Access Compliance Report

Public Rights-of-Way

Intersection ID: 16241	Main Street: IDLEWOOD_CR	Cross Street: LILAC_RD	Location: NW
ADA ID: 08ACE5F95AC8	Ramp Type: PerpDiag	Initial Pass/Fail: Fail	Overall Compliance: No
		Severity Score: 37.5

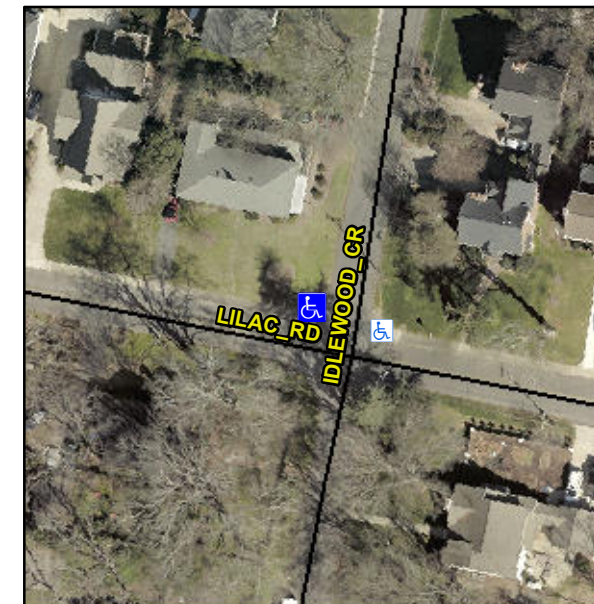
Not Found, R304.2.2, R304.5.3

Compliance	Description	Data	Compliance	Description	Data
N/A	Ramp Length (in)	53.0	No	Ramp Slope (%)	16.6
Yes	Ramp Width (in)	57.0	No	Ramp XSlope (%)	6.6
N/A	Flare Type LT	N/A	N/A	Flare Type RT	N/A
N/A	Flare Slope LT (%)	N/A	N/A	Flare Slope RT (%)	N/A
N/A	Flare Traversable LT?	N/A	N/A	Flare Traversable RT?	N/A
N/A	Landing Length (in)	N/A	N/A	DWS Provided?	N/A
N/A	Landing Width (in)	N/A	N/A	DWS Contrast?	N/A
N/A	Landing Slope (%)	N/A	N/A	DWS Length (in)	N/A
N/A	Landing X Slope (%)	N/A	N/A	DWS Full Width?	N/A
N/A	Landing Curb? (Y/N)	N/A	N/A	DWS Offset (in)	N/A
N/A	Shared Landing?	N/A			
N/A	Gutter Ponding?	N/A	N/A	Gutter Slope (%)	N/A
N/A	Gutter Lip Ht (in)	N/A	N/A	Gutter X Slope (%)	N/A
N/A	Painted X Walk1?	No	N/A	Painted X Walk2?	No
	X Walk 1 Direction	To SW		X Walk 2 Direction	To SE
N/A	X Walk 1 Width (in)	N/A	N/A	X Walk 2 Width (in)	N/A
	X Walk 1 Slope (%)	5.9		X Walk 2 Slope (%)	0.2
	X Walk 1 X Slope (%)	1.4		X Walk 2 X Slope (%)	5.6

Remove & Replace Curb Ramp With Two New Directional Ramps or Equivalent.
